Form C-103
Revised July 18, 2013

SUNDRY NOTICES AND REPORTS ON WELLS
(DO NOT USE THIS FORM FOR PROPOSALS TO DRILL OR TO DEEPEN OR PLUG BACK TO A DIFFERENT RESERVOIR. USE "APPLICATION FOR PERMIT" (FORM C-101) FOR SUCH PROPOSALS.)

7. Lease Name or Unit Agreement Name
NDDUP Unit

EOG Y Resources, Inc. plans to plug and abandon this well as follows:

Proposed:

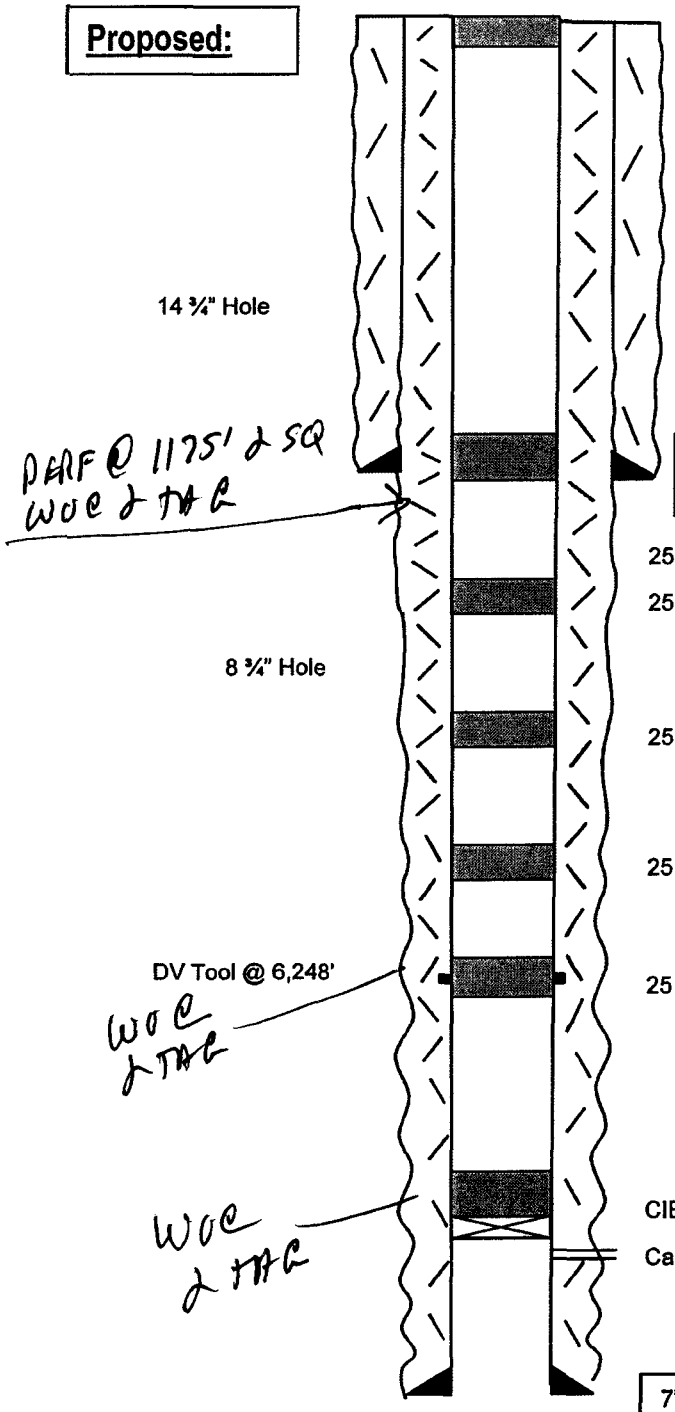
5. Load hole with plugging mud. Spot a 25 sx Class "C" cement plug from 2146'-1996'. This will place a plug across Glorieta.
6. Load hole with plugging mud. Spot a 25 sx Class "C" cement plug from 1175'-1025'. This will place a plug across casing shoe. WOC and tag. PERF AT 1175' & SQUEEZE

13. **All Casing Shoes Will Be Perforated and Attempted to be Squeezed, cement needs to be 50' above and 50' Below Casing Shoe inside the Production Casing** -50' BELOW SHOE
